# Work Variance Request Form

## PG&E TOPOCK GROUNDWATER REMEDIATION PROJECT

### Work Variance Request #16 – Relocate MW-DD to IM3 Access Road

PARTIAL APPROVAL FOR WORK VARIANCE #16 - RELOCATION OF ARSENIC MONITORING WELL (MW-DD) TO IM-3 ROAD - PACIFIC GAS AND ELECTRIC (PG&E) TOPOCK COMPRESSOR STATION, NEEDLES, CALIFORNIA (EPA ID NO. CAT080011729)/(DTSC SITE CODE: 540015)

**Figure 2.2-9. Freshwater Injection System Decision Rules/Operational Framework**

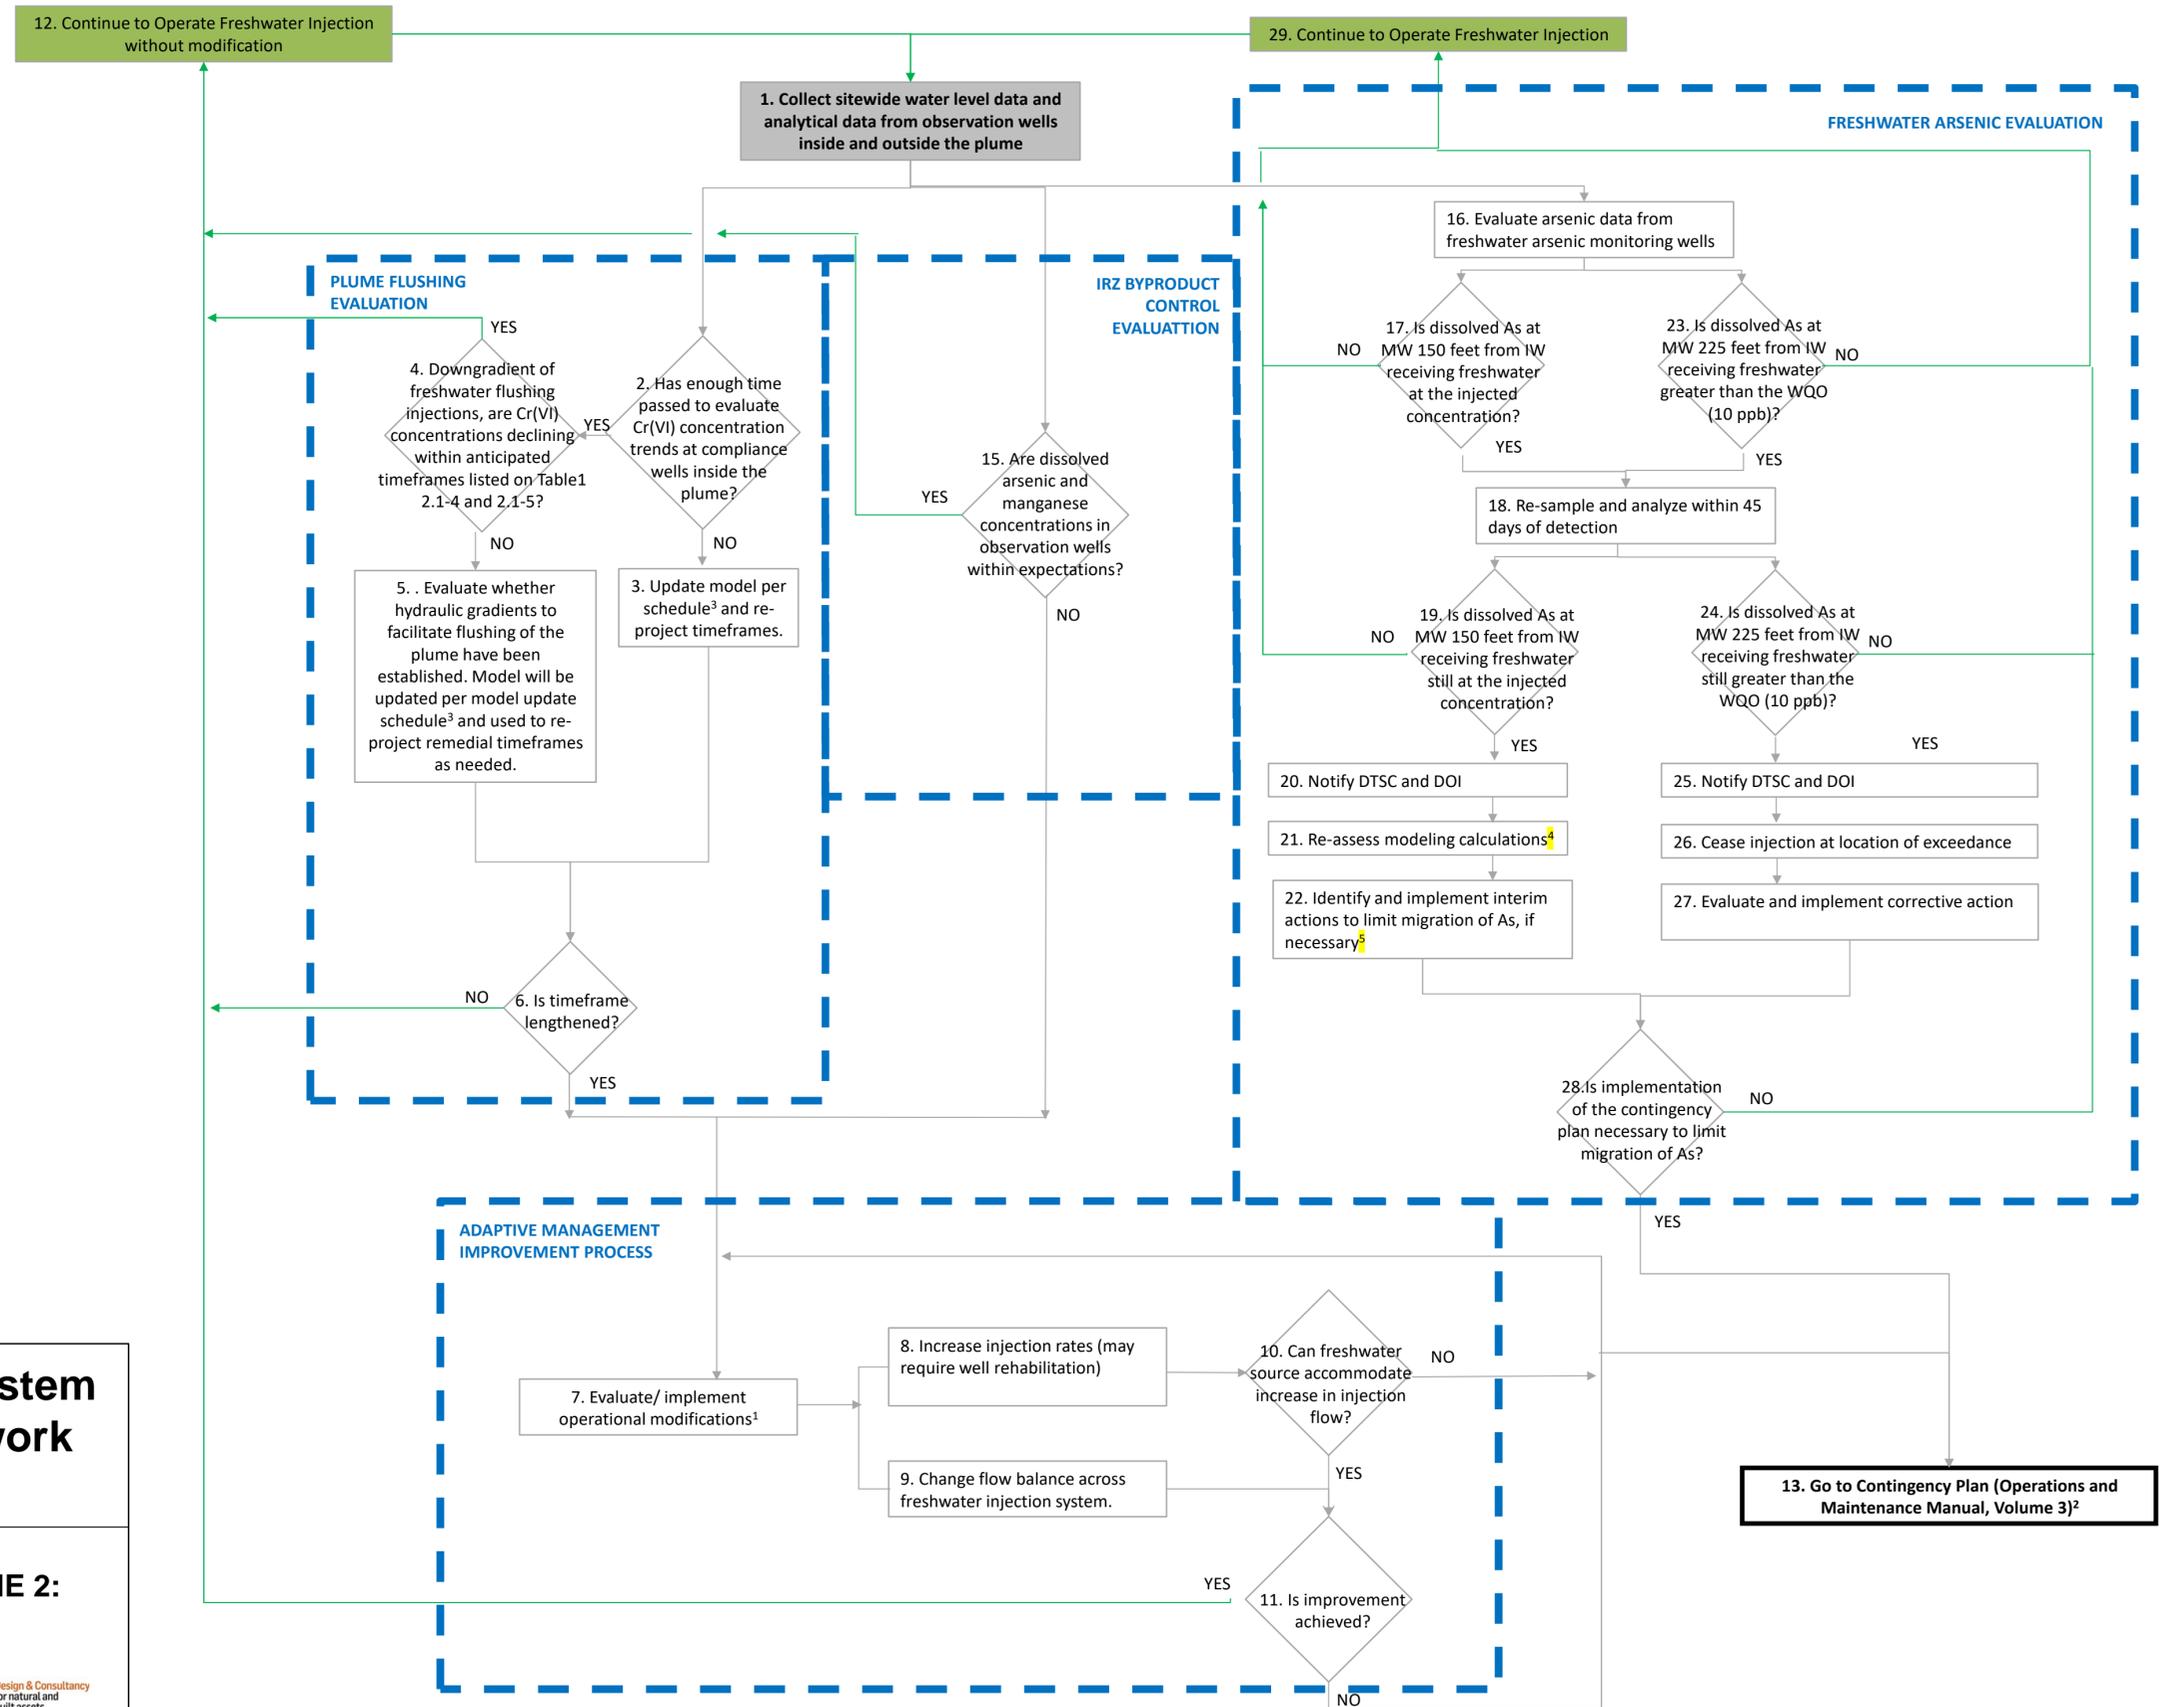
Concerns with potential future arsenic exceedances at MW-DD and other arsenic monitoring wells can be addressed with the flowchart, Figure 2.2-9: Freshwater Injection System Decision Rules/Operational Framework, contained within the approved 2015 BOD as it provides an appropriate framework to mitigate and solve potential future arsenic exceedances. In the case of well MW-DD, an arsenic exceedance will likely require the installation of provisional well MW-EE as envisioned in the 2015 BOD.

DTSC accepts the work variance request documenting the relocation of MW-DD into the IM-3 road. However, DTSC specifically rejects both of PG&E's proposals to modify the procedure for freshwater arsenic evaluation on the basis that these requests differ from what is documented in the approved 2015 BOD and the November 20, 2013 State Water Resources Control Board letter. Currently, there are adequate arsenic evaluation measures and guidance identified in Figure 2.2-9 titled *Freshwater Injection System Decision Rules/Operational Framework* found in the *Operational and Maintenance Manual, Volume 2: Sampling and Monitoring Plan*, which should be followed.

TOPOCK GROUNDWATER REMEDIATION PROJECT  
**MW-DD TEMPORARY  
 DRILLING PAD**  
 GAS TRANSMISSION & DISTRIBUTION  
 PACIFIC GAS AND ELECTRIC COMPANY  
 SAN FRANCISCO, CALIFORNIA

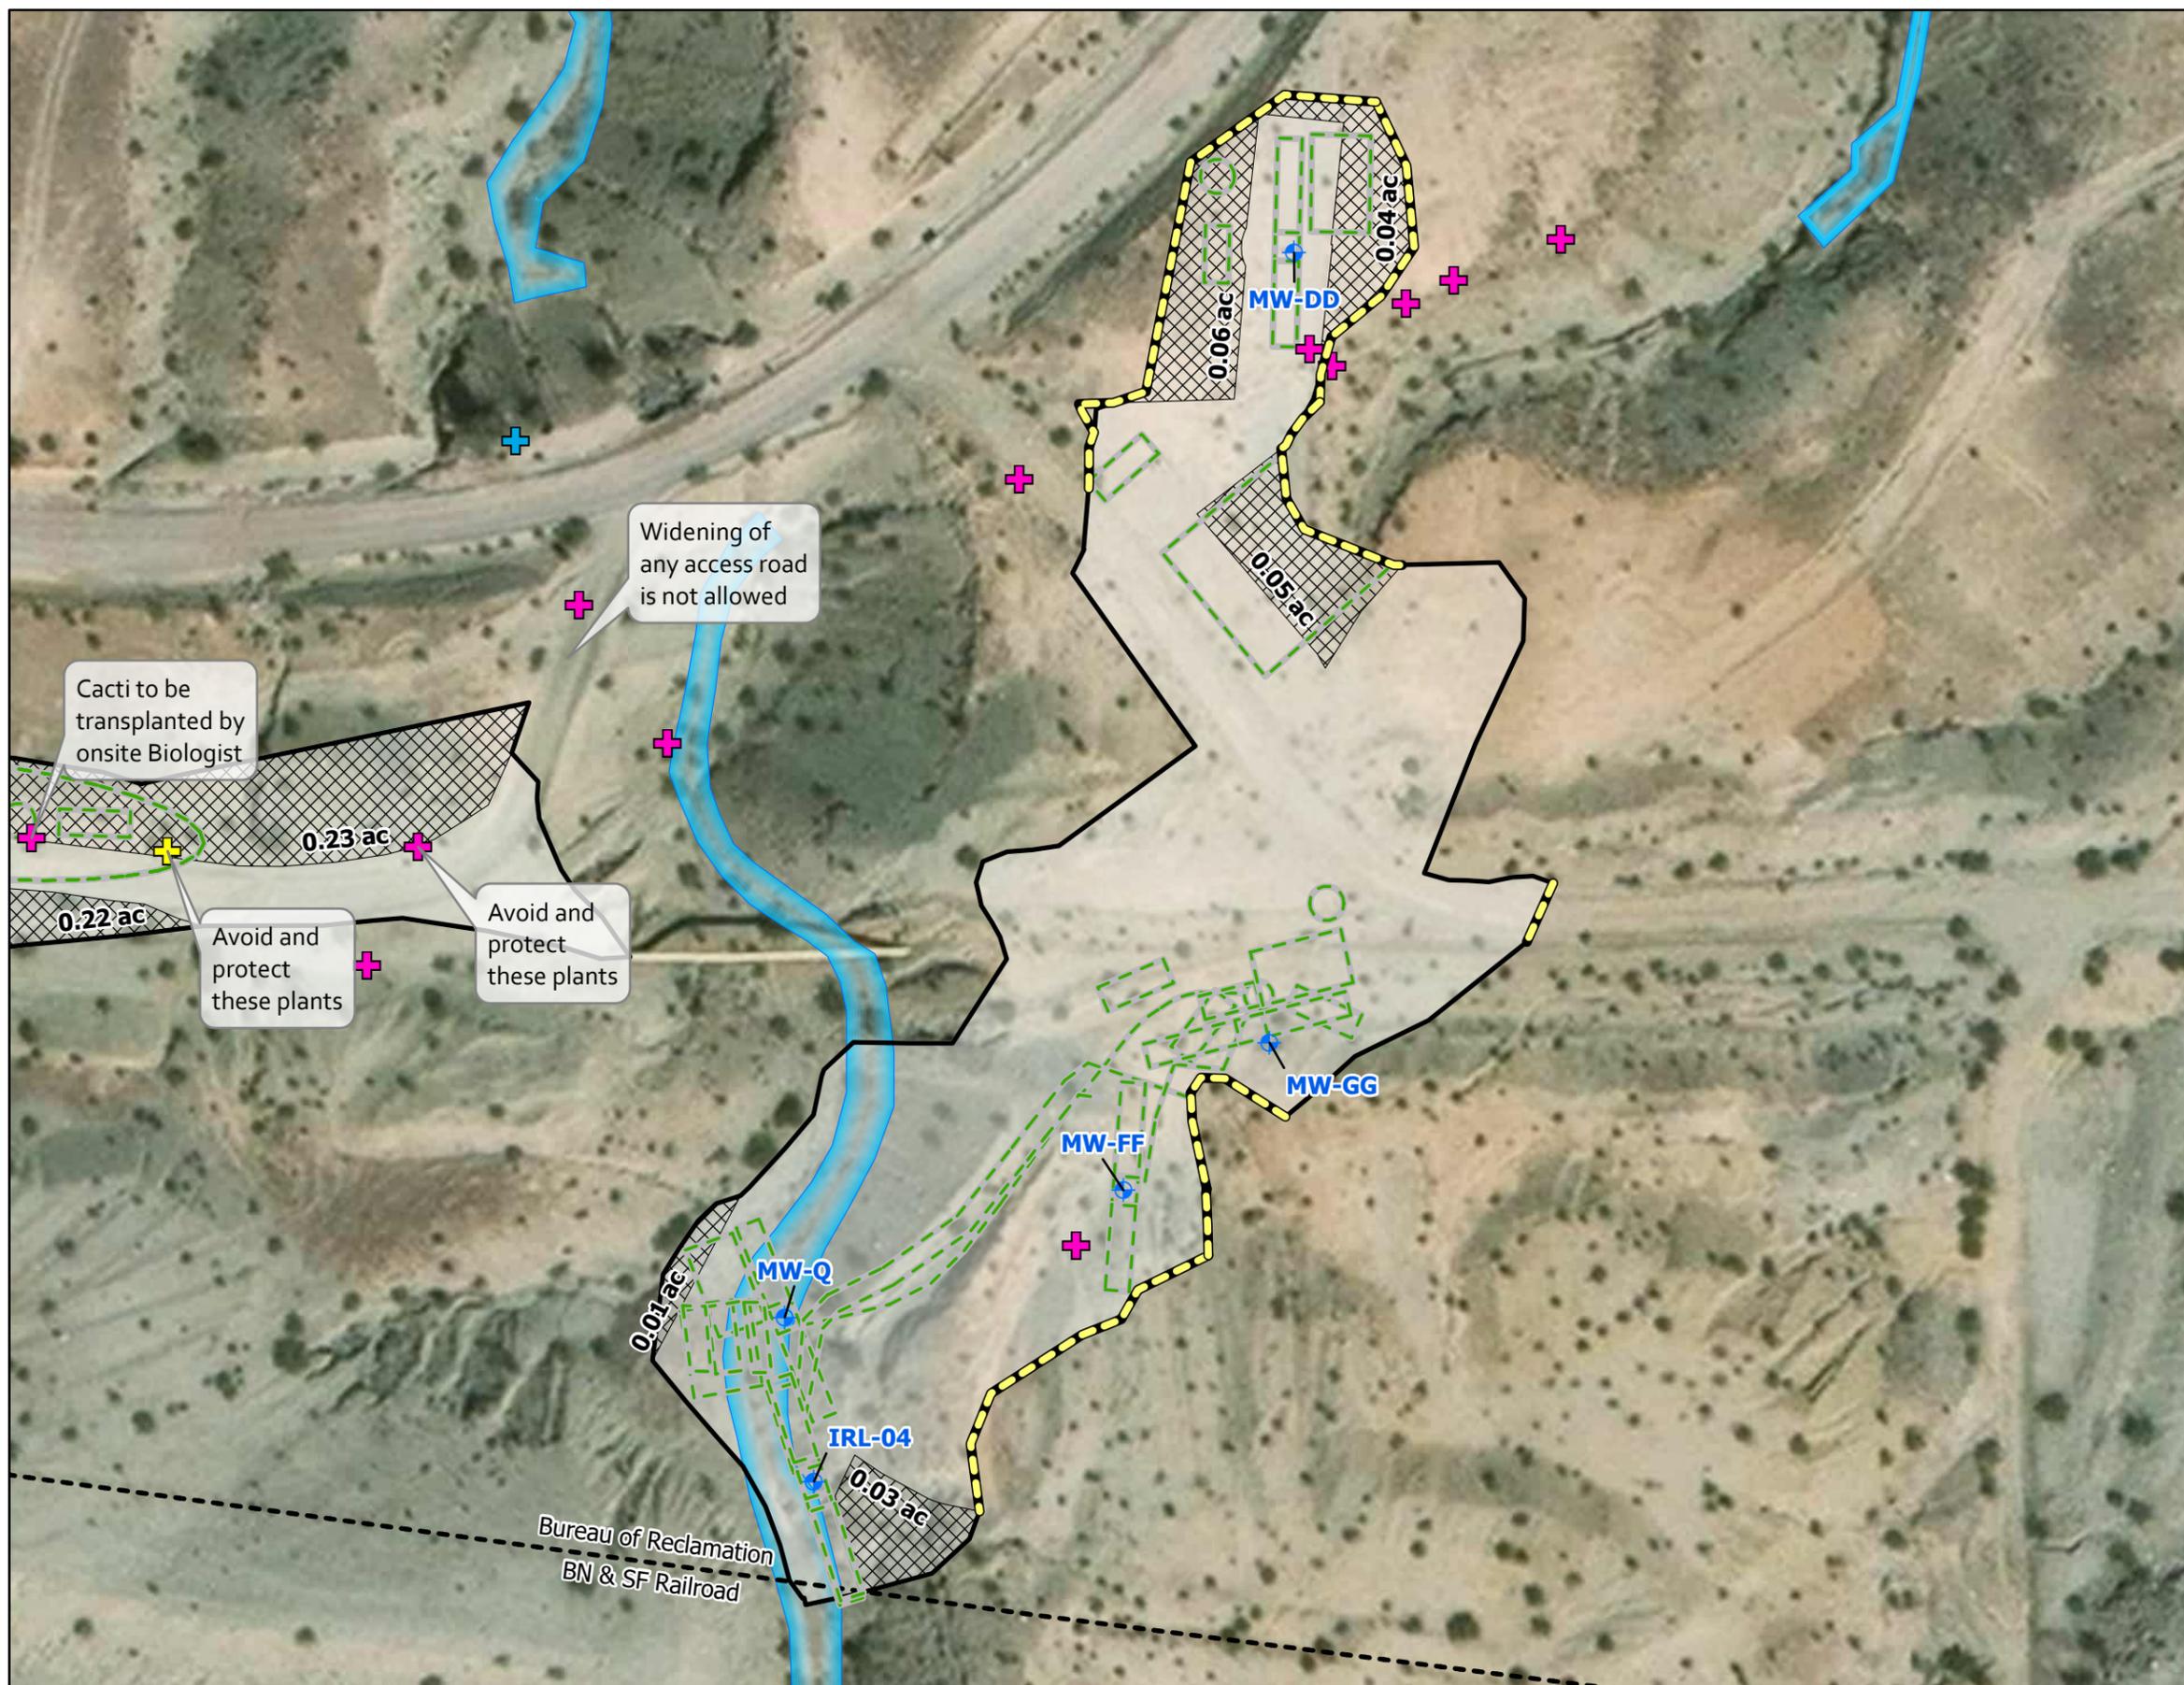
Note that C-108 reflects the following change to reduce the footprint in the area of MW-DD: the freshwater tank and phase separator will not be staged in the immediate vicinity of the rig as previously shown in Figure 3 of ERTC 5bb (see attached); instead, these components will be staged in an area that has already been disturbed with temporary pipelines running to the rig.

**IRL-3 ARSENIC MONITORING WELL  
LOCATIONS**

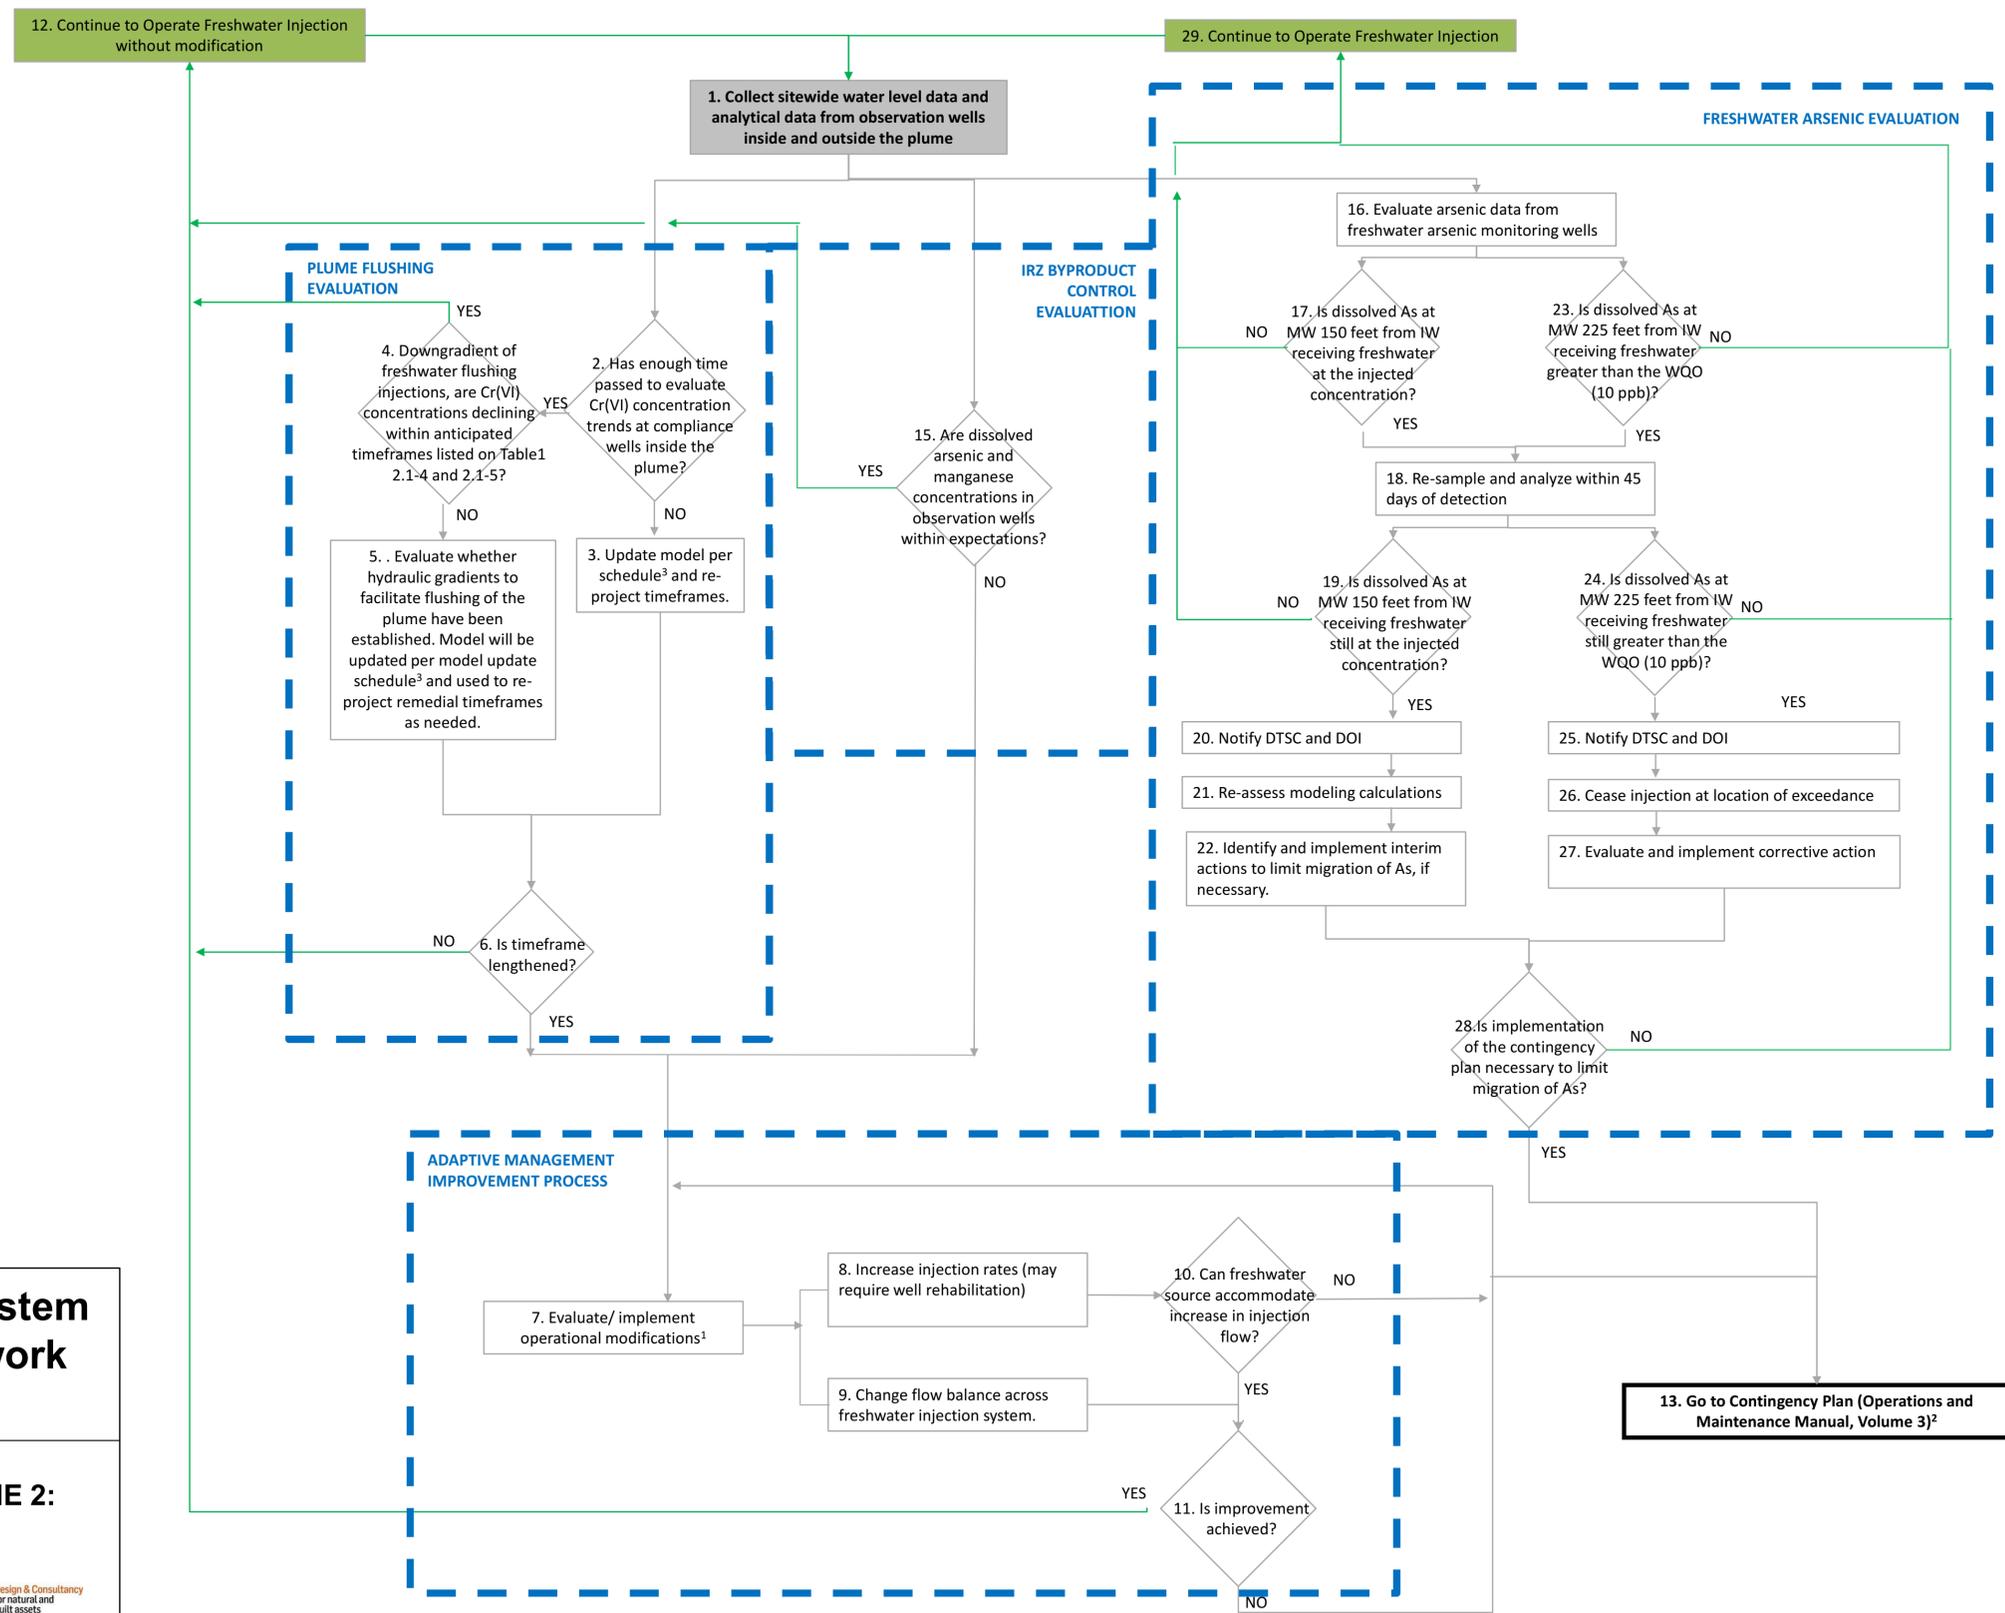
Upon technical review of the approved 2015 Basis of Design (BOD) groundwater remedy design and model, it was determined the best alternative location for MW-DD would be in the IM-3 road at the location referred to as "MW-DD IM3 Road". Furthermore, relocating MW-DD into the IM-3 road would cause minimal disturbance as far as potentially impacting cultural and historic resources.

In a July 7, 2025 email, DTSC requested PG&E to assist agencies by preparing figures illustrating the foot print/Work Area Boundaries for both well MW-DD as proposed in the 2015 BOD as well as the MW-DD location in the IM-3 Access Road (MW-DD IM3 Road) as observed on June 16, 2025. On July 29, 2025, PG&E responded via letter titled *Well MW-DD Location Update, PG&E Topock Compressor Station, Needles, California*. The PG&E letter comments on the uncertainty in the groundwater model and how adaptive management may be hindered in the future using the MW-DD IM3 Road location but does not provide any data to support this concern.

For these reasons, DTSC in concurrence with DOI, find it technically sound to relocate MW-DD to the IM-3 road and directs PG&E to relocate this well to the MW-DD IM3 Road location and prepare a Work Variance Request for MW-DD's relocation as soon as possible.
